REGULAR MEETING AGENDA

Tuesday, December 12, 2023

Staff Report
DealPoint Merrill – Self-Storage
2515 Ellsworth Road, Ypsilanti MI
Site Plan

**Preliminary Site Plan and Special Conditional Use Review
For
Ypsilanti Township, Michigan**

AS1.02
Site Plan
Phase 1

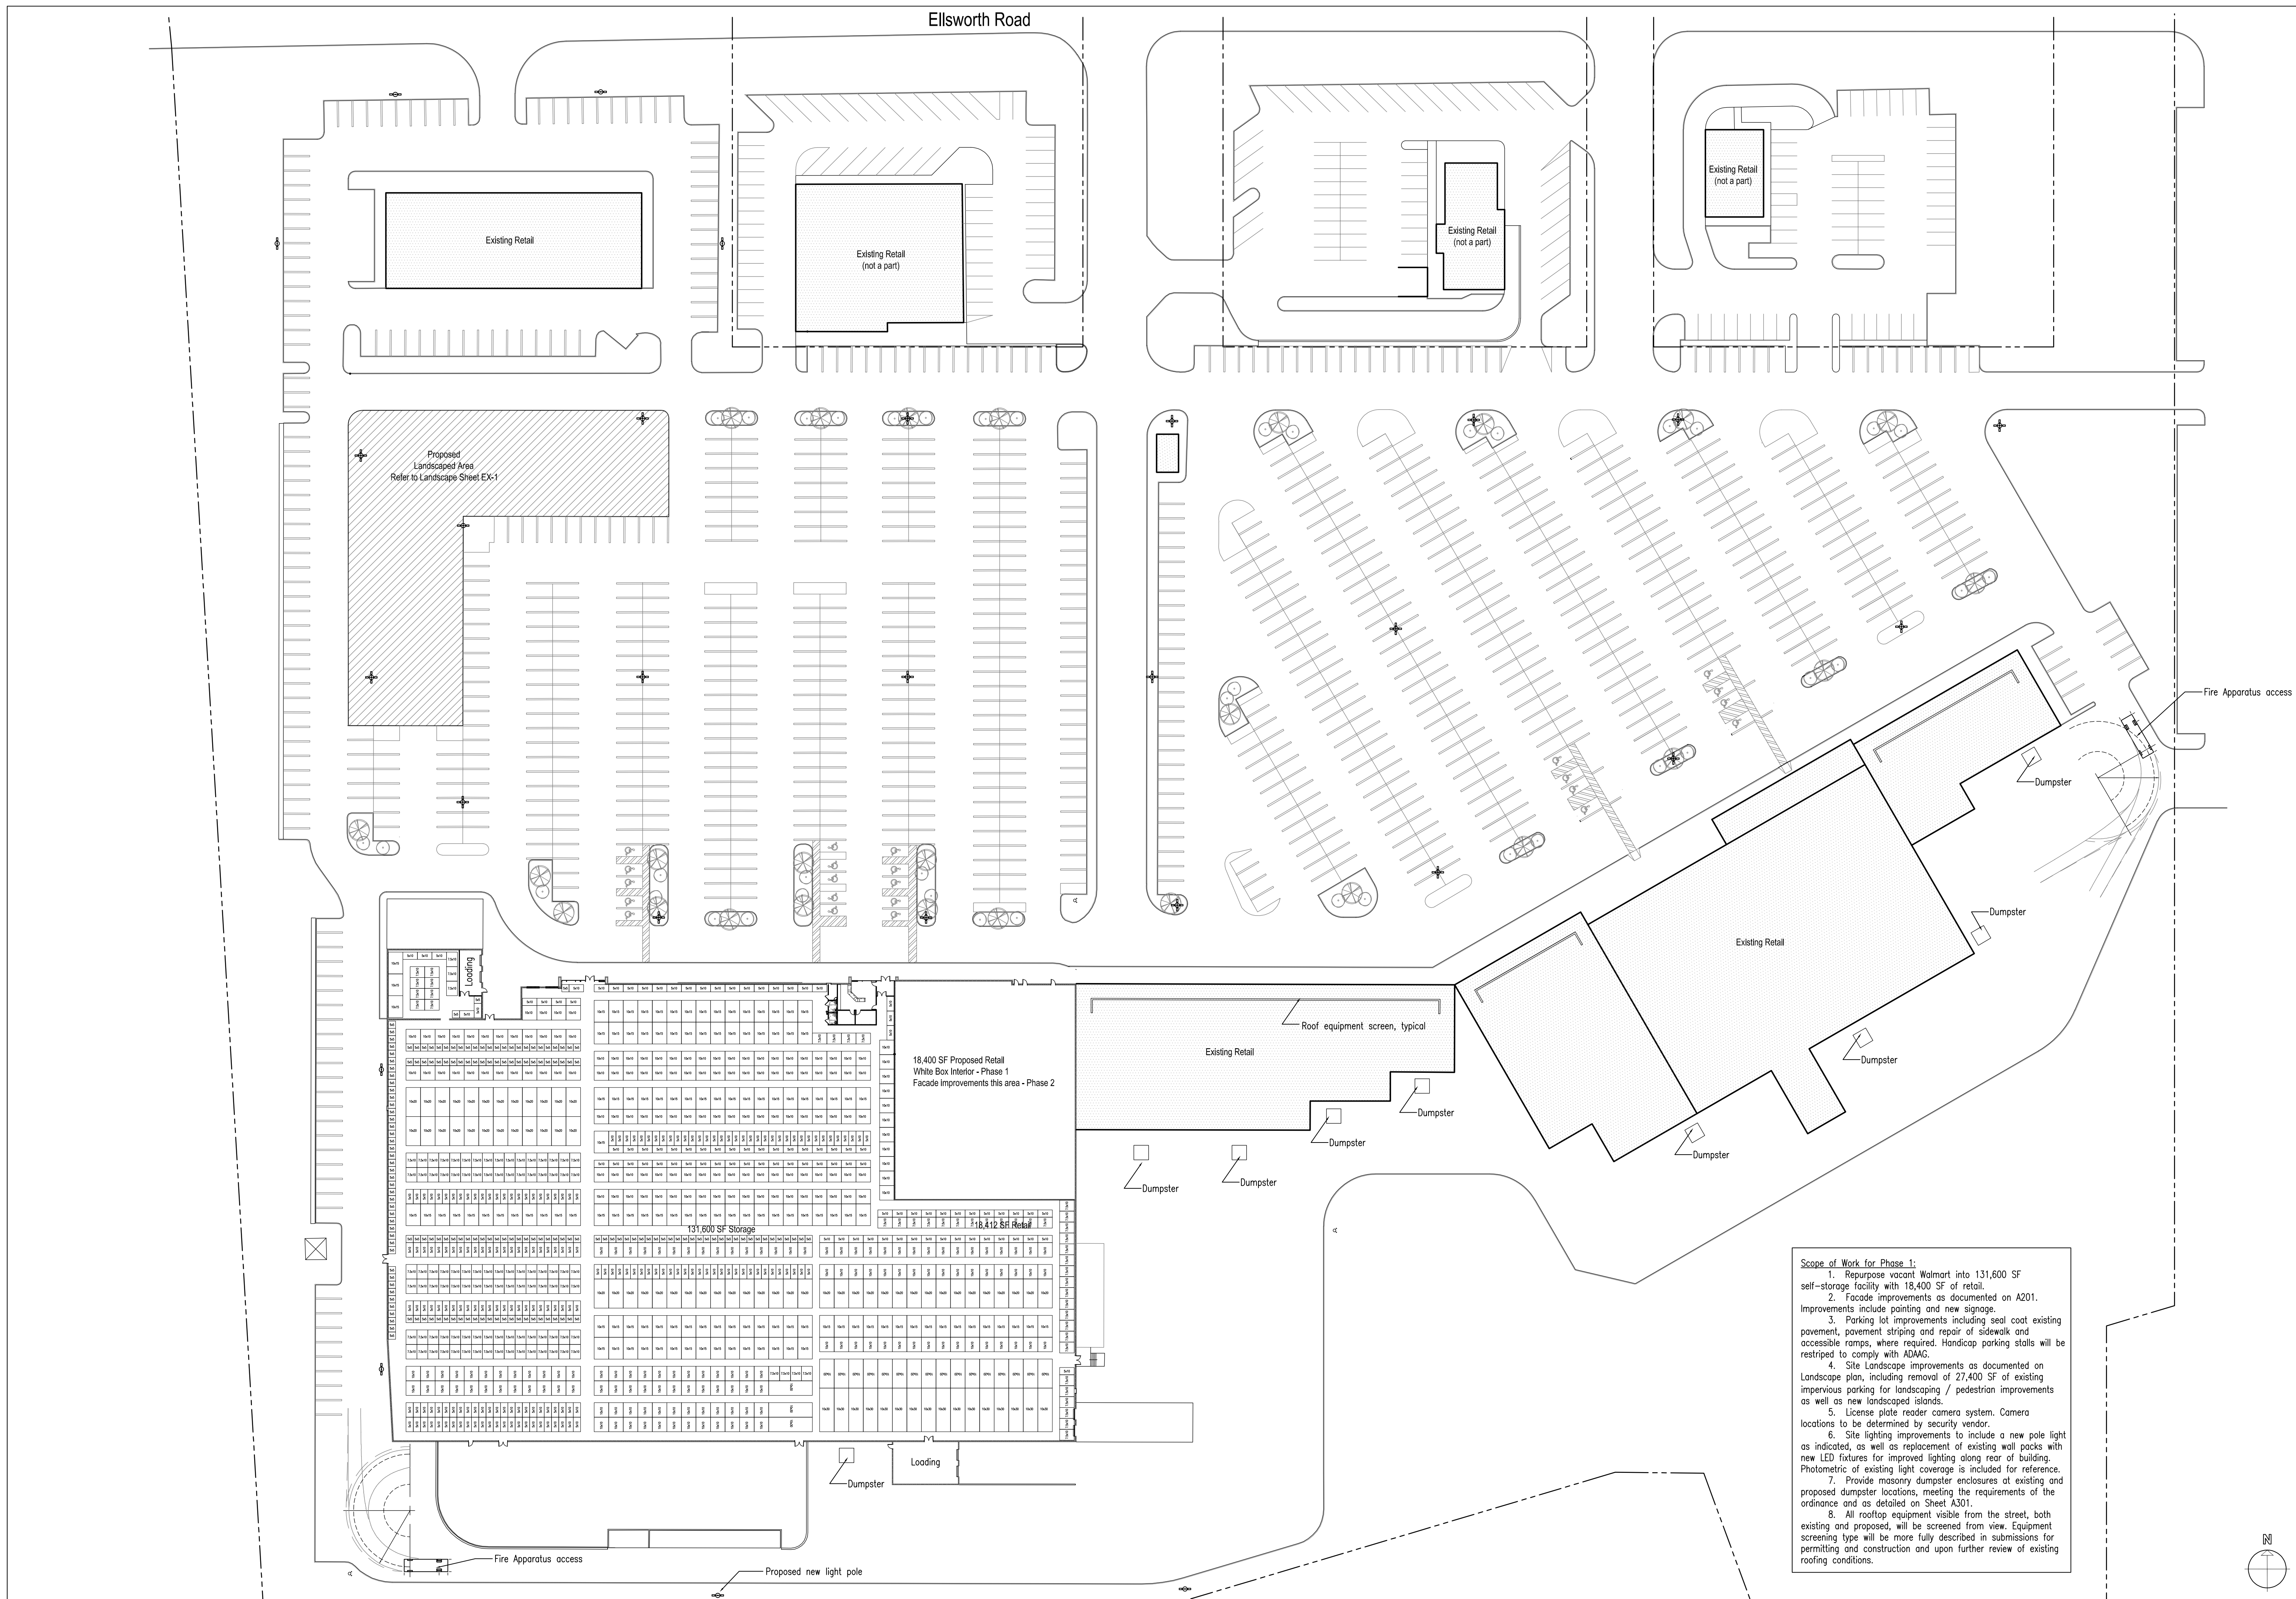
1. Dumpster Enclosures: Dumpster locations are indicated on the site plan AS1.01 and AS1.02. Enclosures meeting the requirements of the ordinance will be provided as part of Phase 1, re: A3.01.
2. Rooftop equipment screening will be provided as part of Phase 1. Refer to AS1.02.
3. Landscaping is provided, re: AS1.02 and EX-1 Landscape Plan.

1. A photometric is provided confirming adequate lighting in the parking lot. As part of Phase 1, an additional light pole will be added in the rear of the proposed storage re: AS1.02. Additionally, all existing wall packs will be replaced with new LED fixtures.

Work to be included as part of Phase 1 is listed on sheet AS1.02. Additionally, existing utilities are provided on the attached updated ALTA survey.

Proposed Facade Improvements

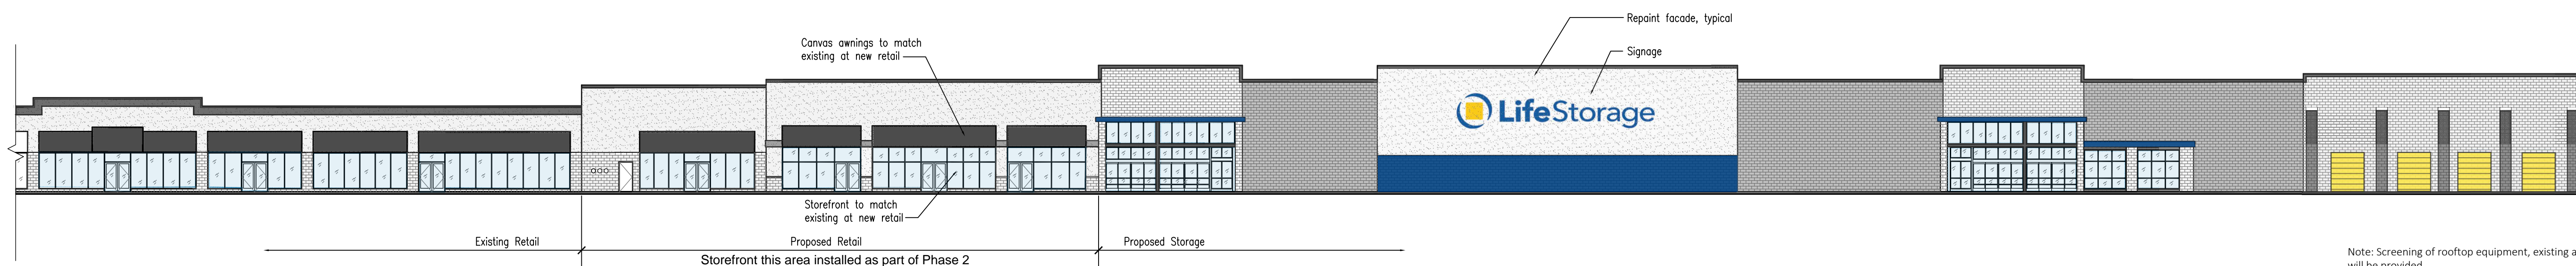
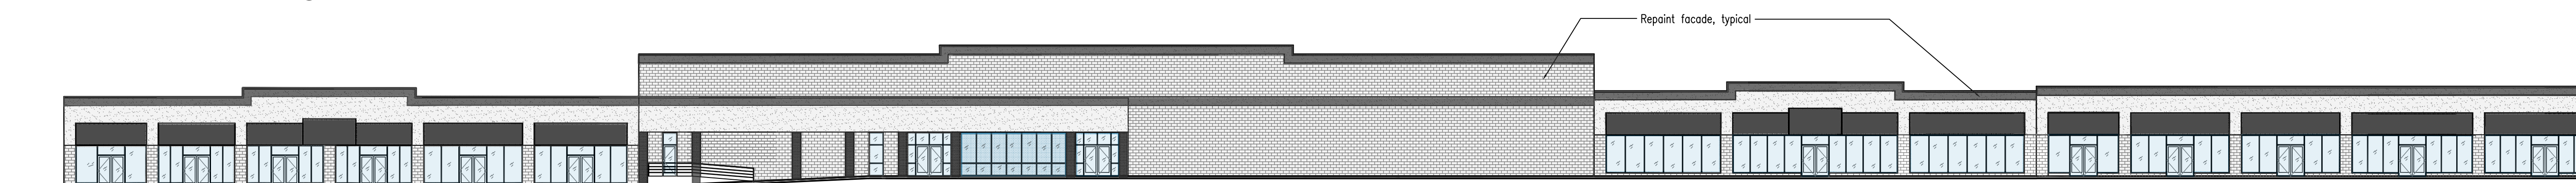
1. Refer to elevations sheet A2.01 for proposed improvements to be provided as part of Phase 1. The storefront for the proposed new retail will be provided as part of Phase 2, once a tenant is identified.
